**REQUEST**

Current Zoning: R-22MF(CD) (multi-family residential)  
Proposed Zoning: UR-2(CD) (urban residential, conditional)

Approximately 10.81 acres located in the western quadrant of the intersection of North Poplar Street and West 28th Street, south of Atando Avenue.

## PLANNING STAFF REVIEW

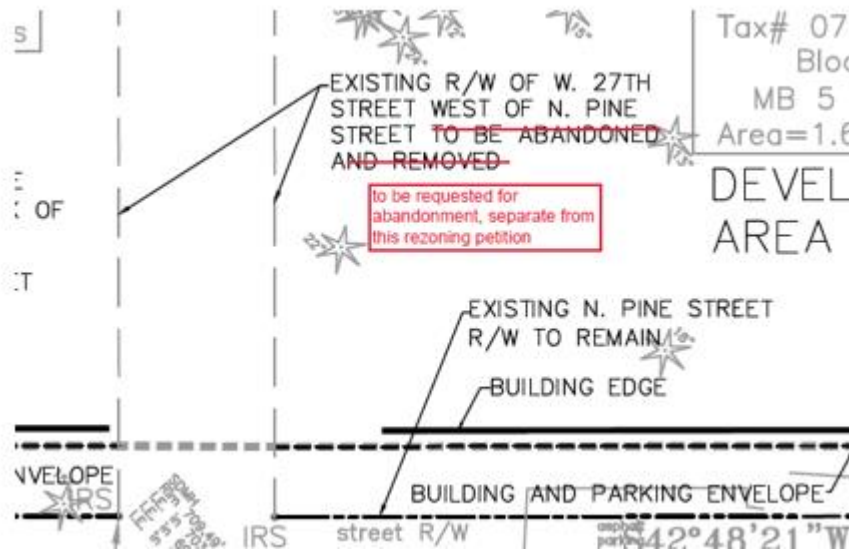
1. Add a conditional note that recessed on-street parking will be provided along all street frontages in accordance with CLDSM.
2. On sheets RZ-1 and RZ-2, remove call-out to abandon and remove W. 27th Street. Also, remove the site conditional note 3. Access, Buffers, Screening, Open Space and Pedestrian Circulation.

Note I. The abandonment of W. 27th Street is not consistent with the USDG Standards.
